STAFF REPORT

AGENDA ITEM: Southwind of Lake Elmo Final Plat

Request: Application for Final Plat approval of a 46 unit single family attached residential subdivision to be named Southwind of Lake Elmo.

SITE PLAN

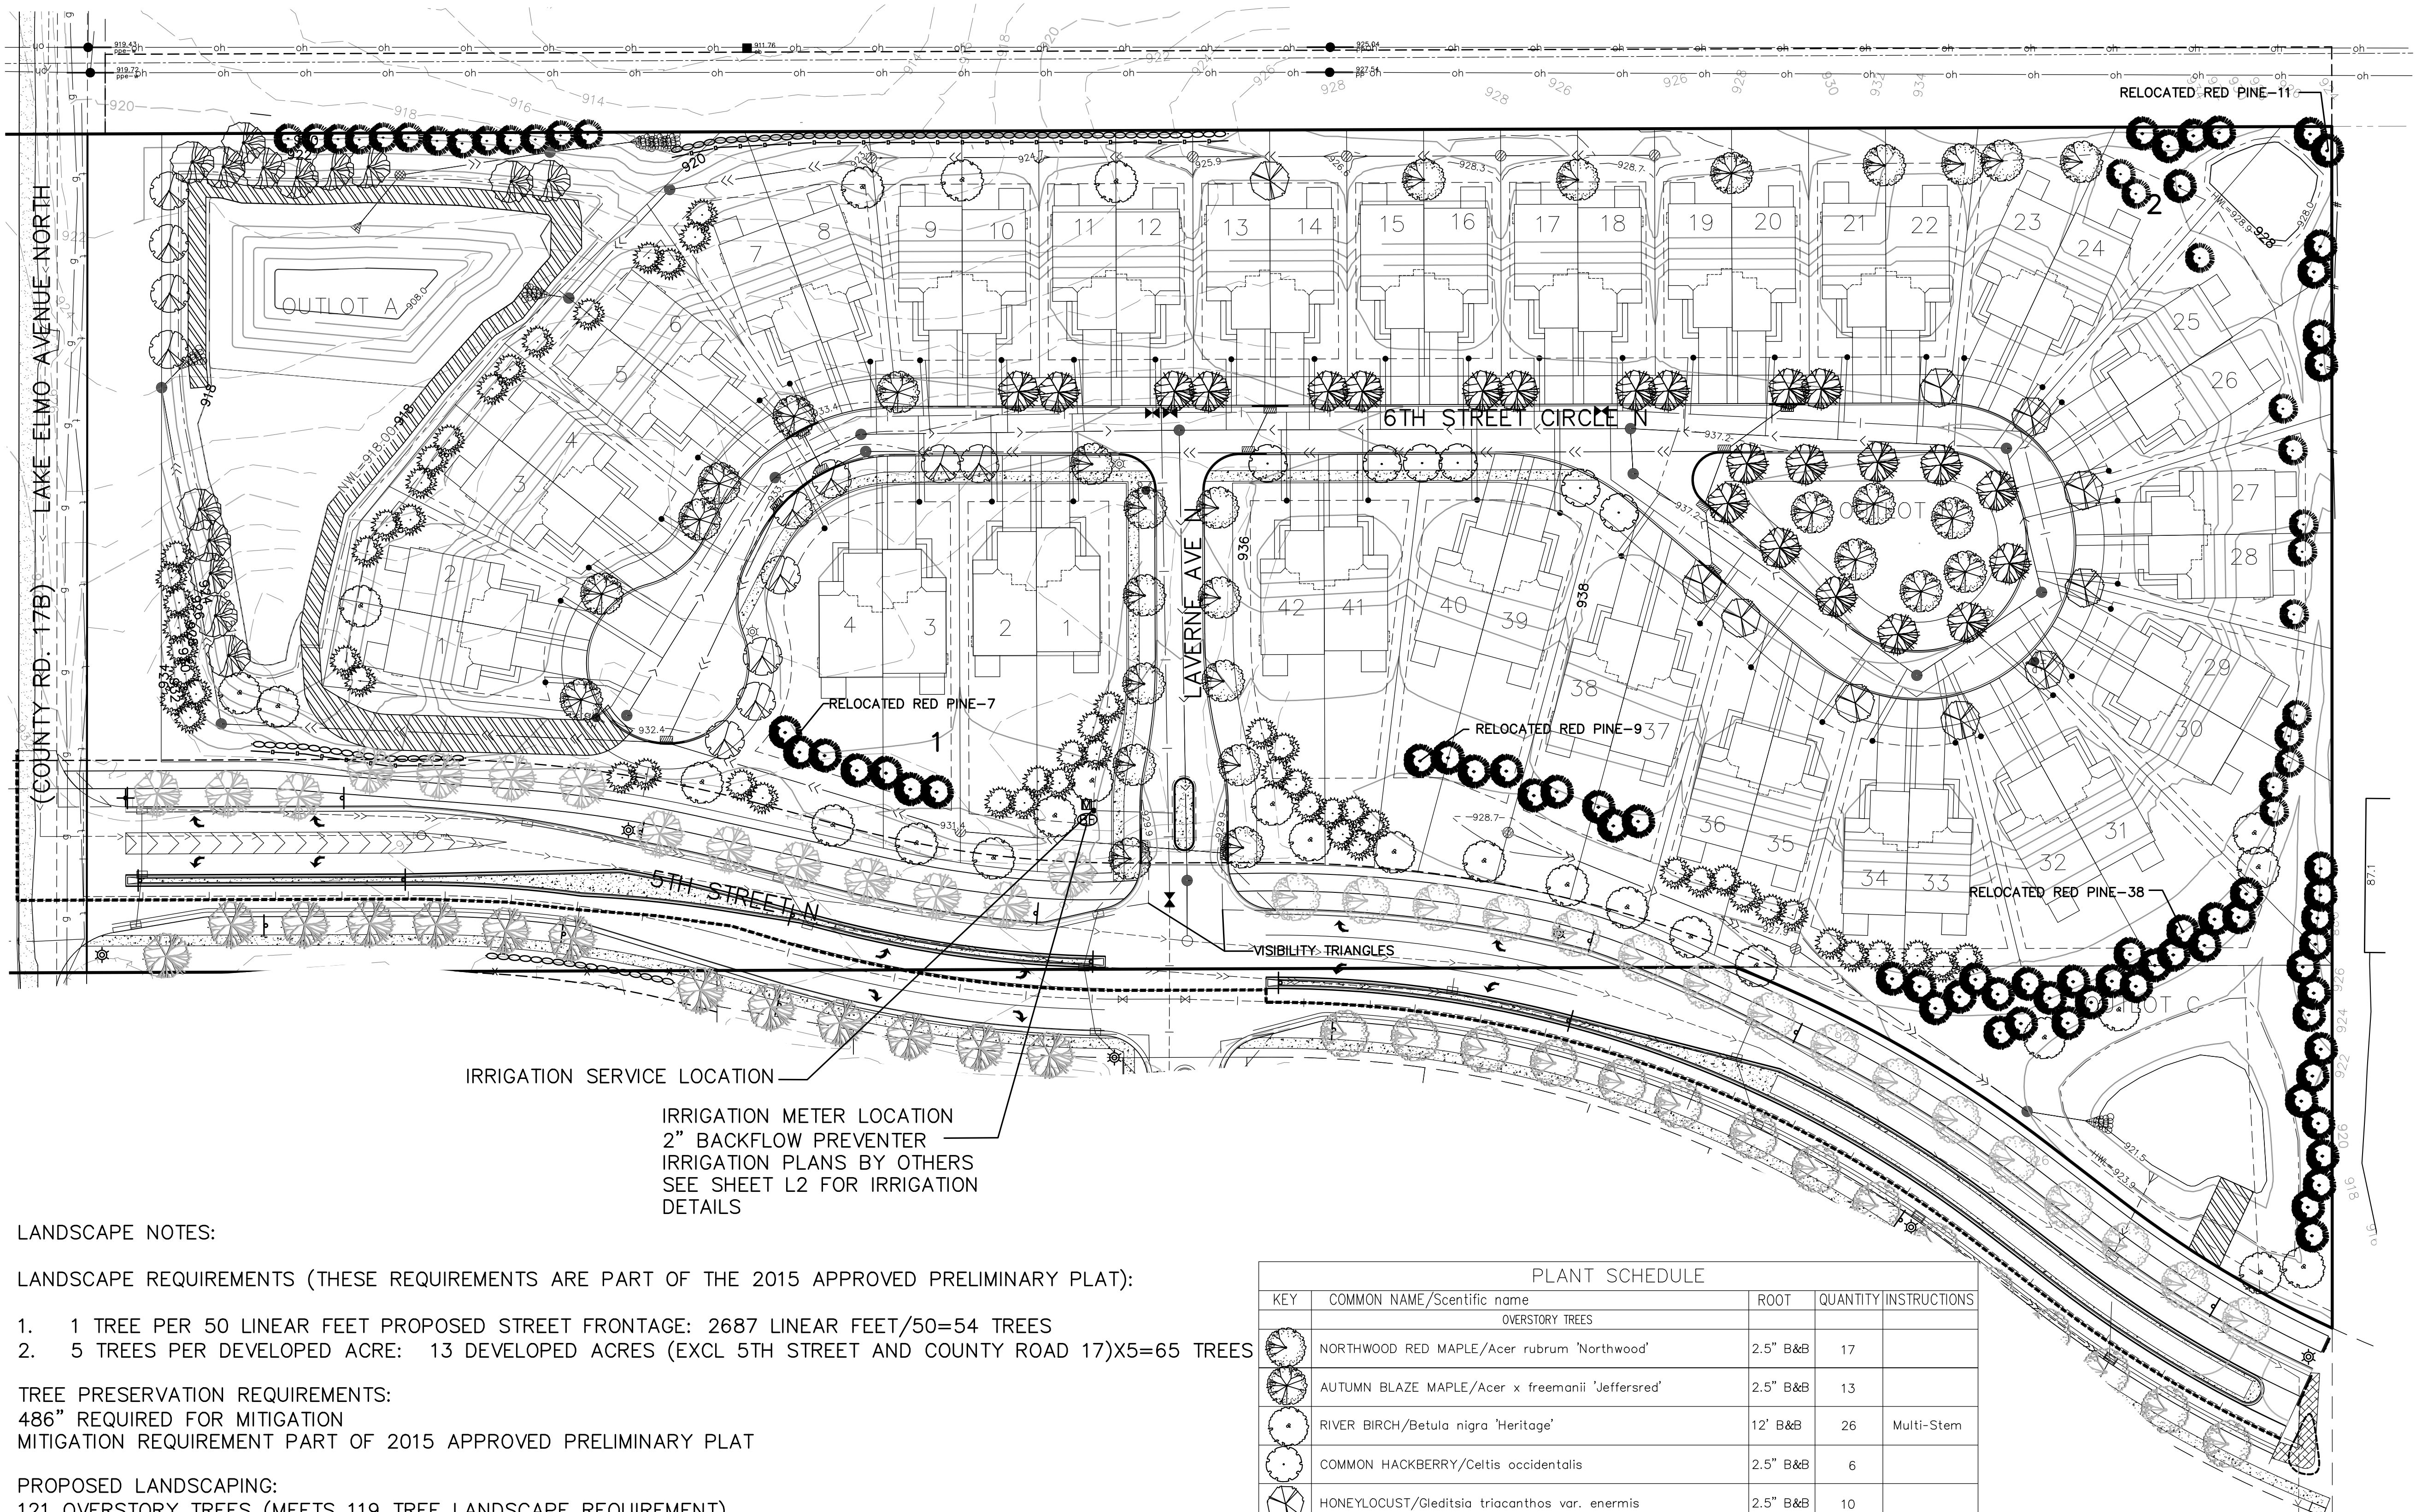
- They commented on the missing trail connection from the westerly cul-de-sac to 5th Street. The developer was questioned as to why this trail connection was eliminated, as the trail connection would connect to the trail on the north end of 5th Street North. The developer did not know why this connection had been eliminated but deduced that it may have been eliminated due to a lack of on-street parking. The Commission would like to see this cul-de-sac connection put back in.

15) That a sidewalk or trail be constructed from the bulb of the westerly cul-de-sac within the development to the trail along 5th Street North. Staff comment: Recommended with an affirmative vote of 5-0.

- 15) That a sidewalk or trail be constructed from the bulb of the westerly cul-de-sac within the development to the trail along 5th Street North.
- 16) The Landscape Plan shall be amended to provide additional buffering behind Lots 26-29 to the extent possible.

LANDSCAPE PLAN

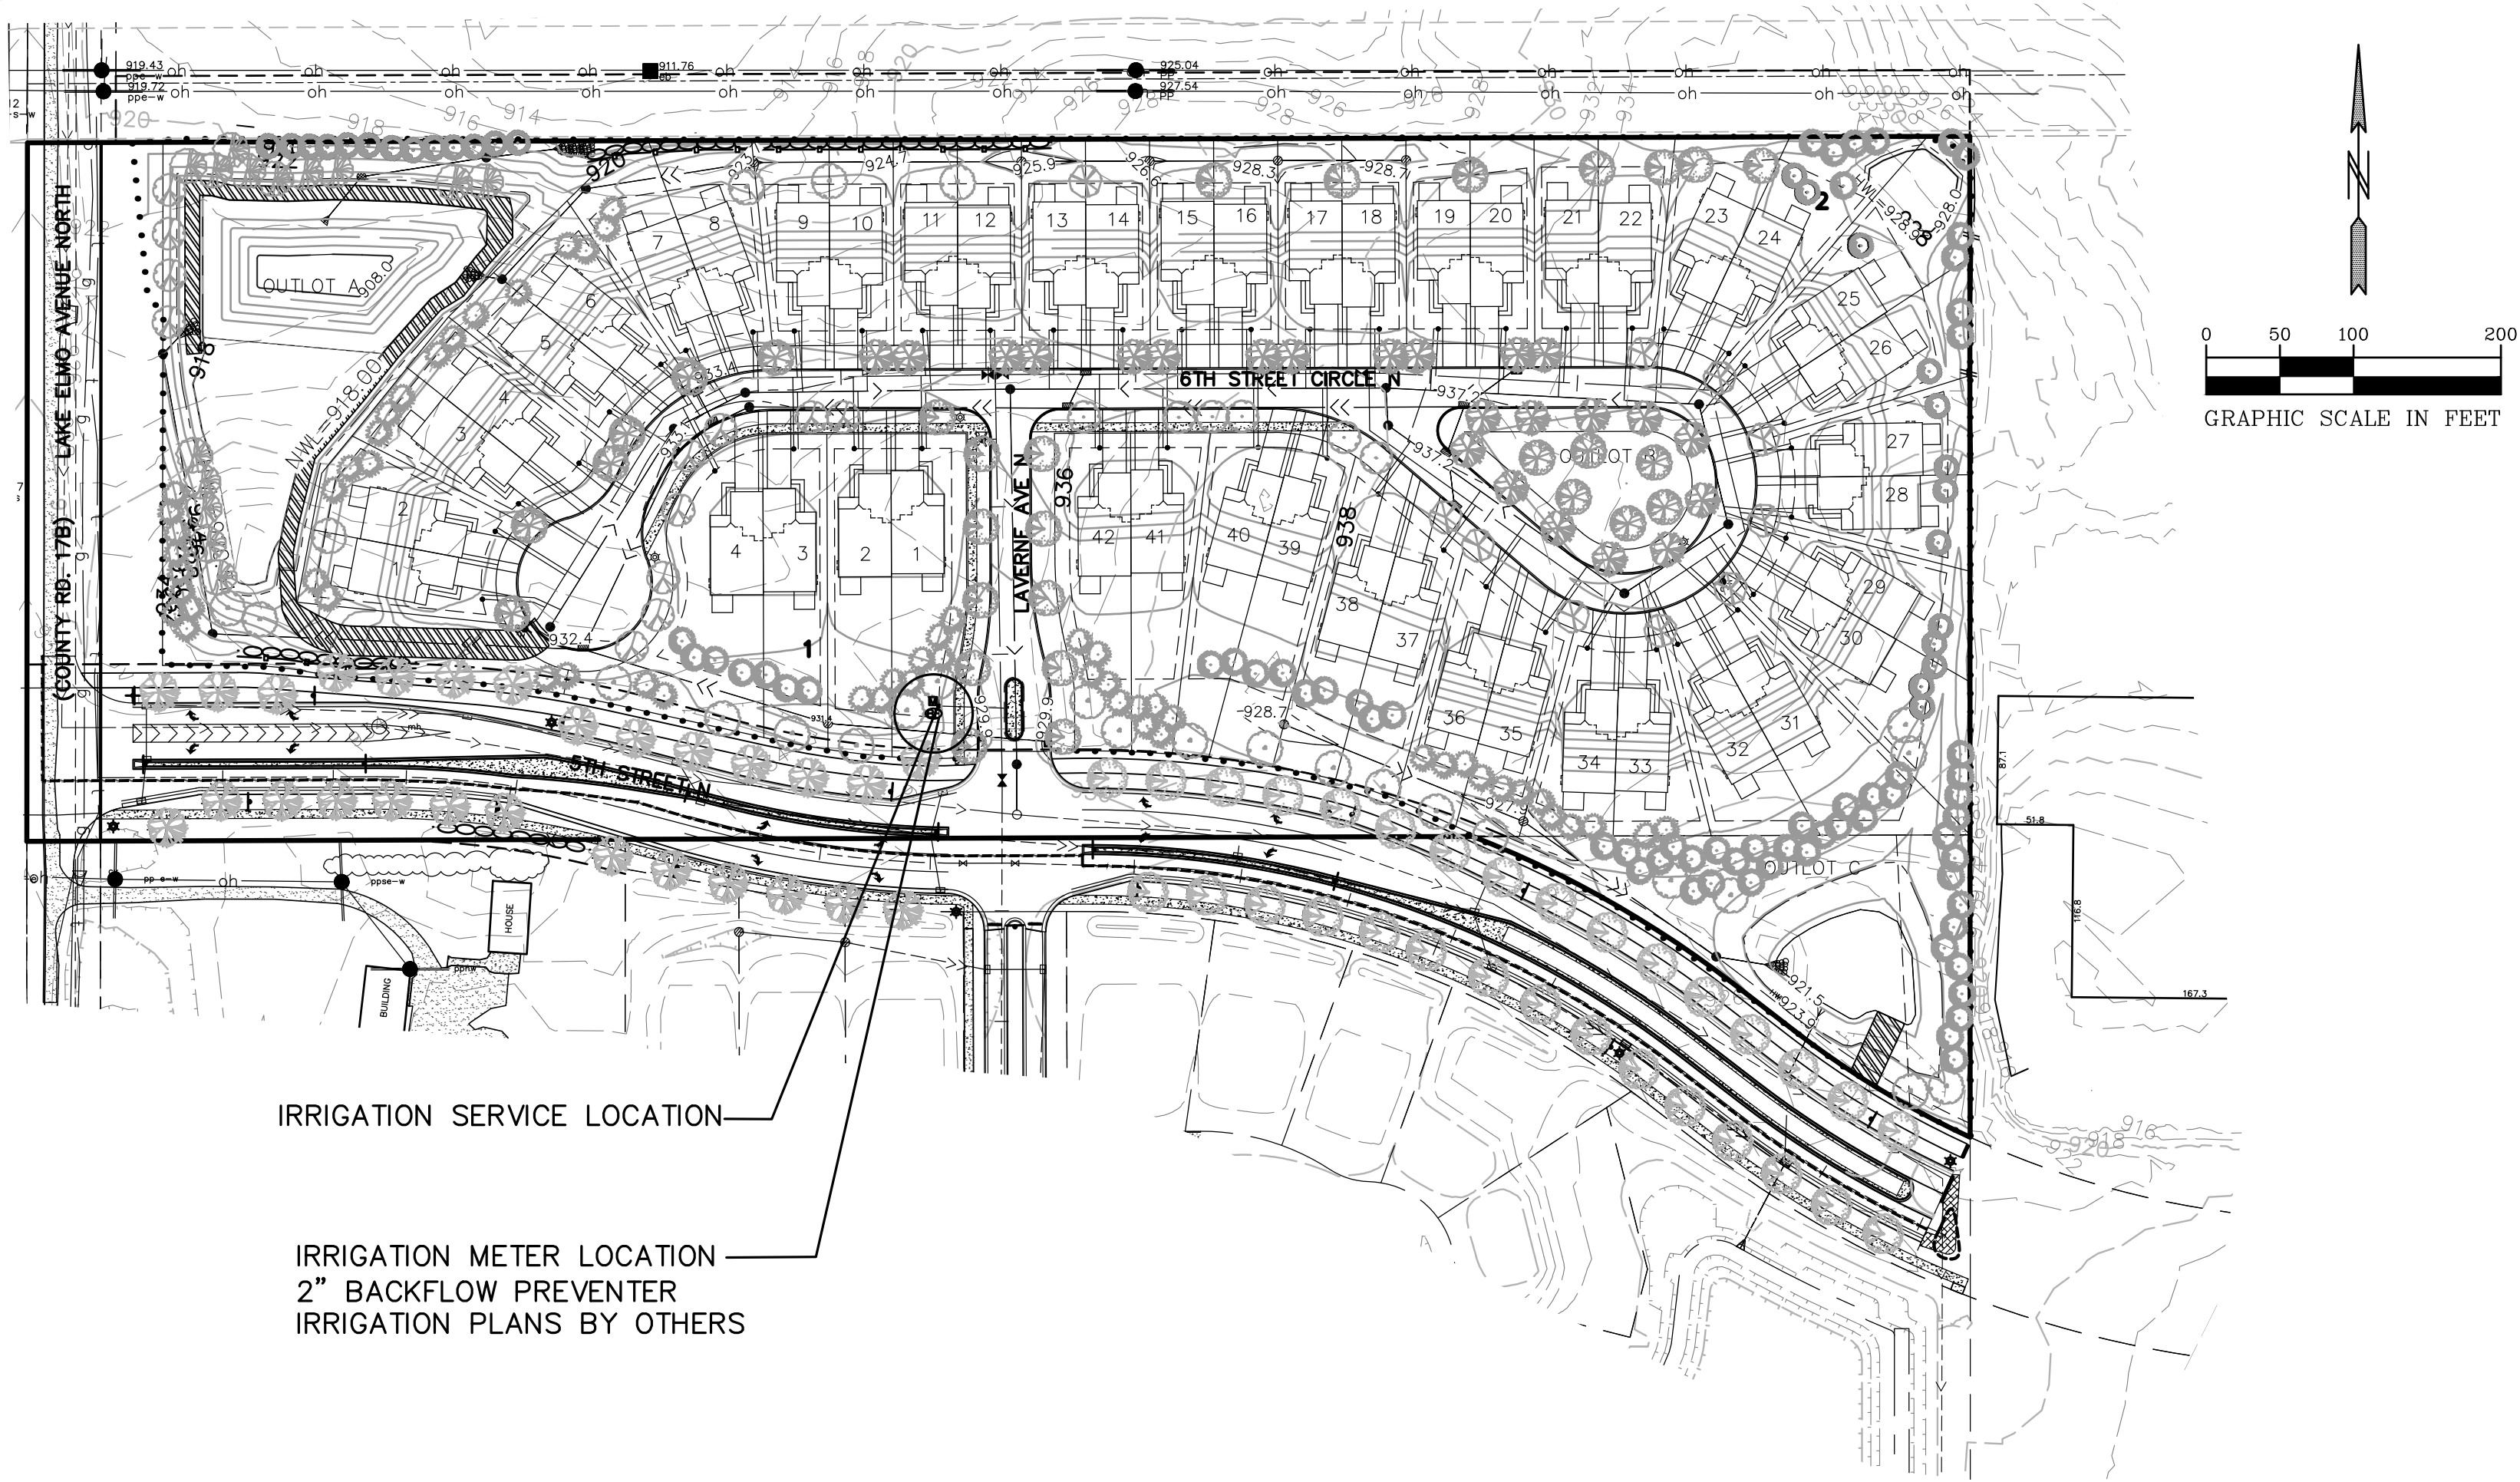
Landscape Plans. The City's Landscape Architect has conducted a review of the Landscape Plans

- There are a number of tree/utility conflicts (Lots 30 and 31 (hydrant), and Lots 28 and 29, tree blocking maintenance bench near Outlot C (the storm pond in the southeast triangle has maintenance access from 5th Street, which will likely impact landscape plans).
- A few of the transplanted pines and other trees are encroaching on the drainage and utility easement behind Lot 33.
- Design and maintenance access to the infiltration basin on the northeast portion of the plat needs to be more clearly defined.
- Approved 5th Street Irrigation Plans are required prior to recording of the Final Plat. This has been added as a condition of approval.

16) The Landscape Plan shall be amended to provide additional buffering behind Lots 26-29 to the extent possible. Staff comment: Recommended with an affirmative vote of 5-0. There is a swale in this area and this may be difficult to execute.
